Waterworks Park Stream Restoration Public Meeting Minutes

Date: 5/6/2026

DEM Difference 2017 to 2023

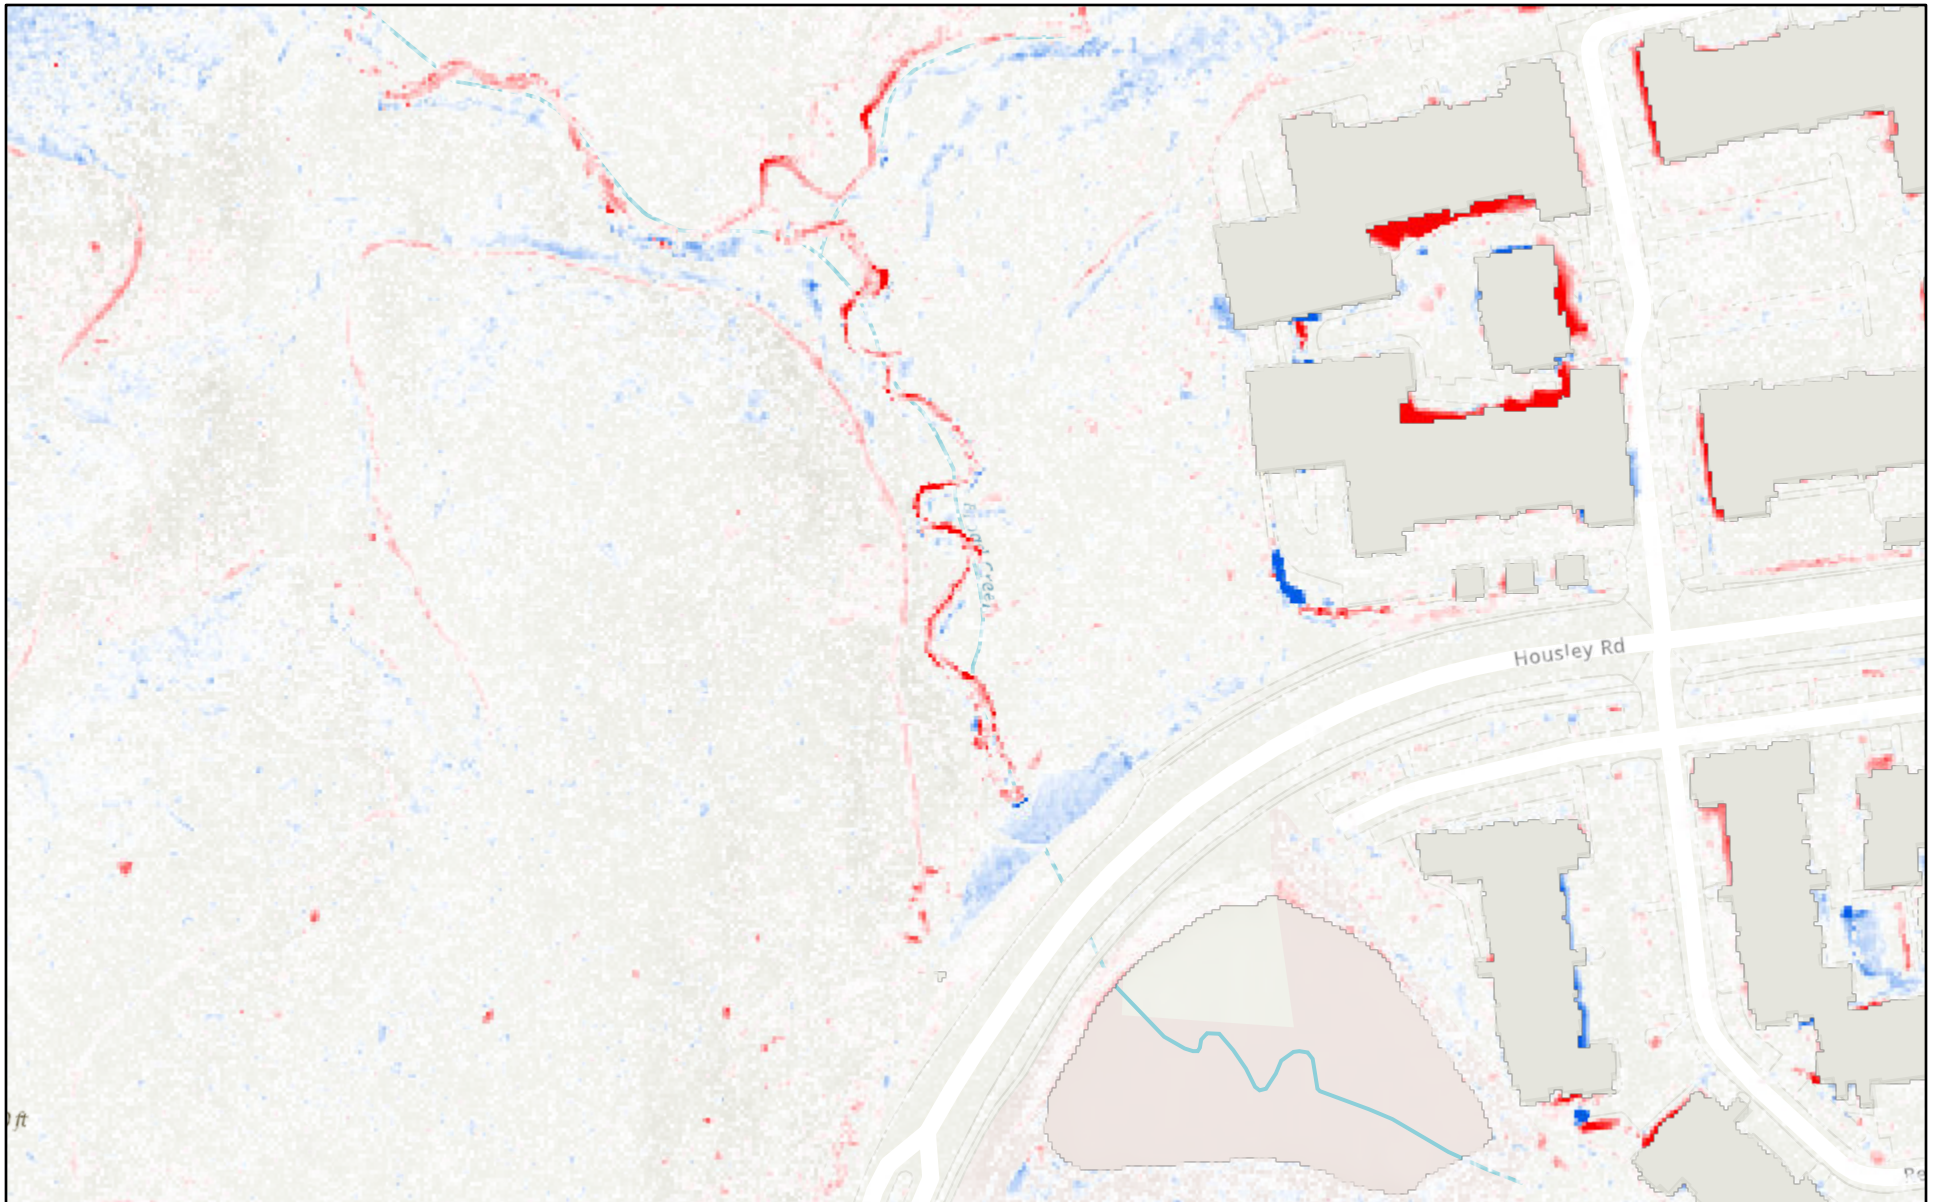
3. What is the evidence that this stream is still eroding? If there is solid evidence that the stream is still eroding, what length of stream is actively eroding?

Attached to this document is LiDAR-based evidence provided by the County of the channel actively eroding from 2017 to 2023. The project design report provides additional information. The initial report is posted on ARF's project website and the final one will be posted as soon as it is available.
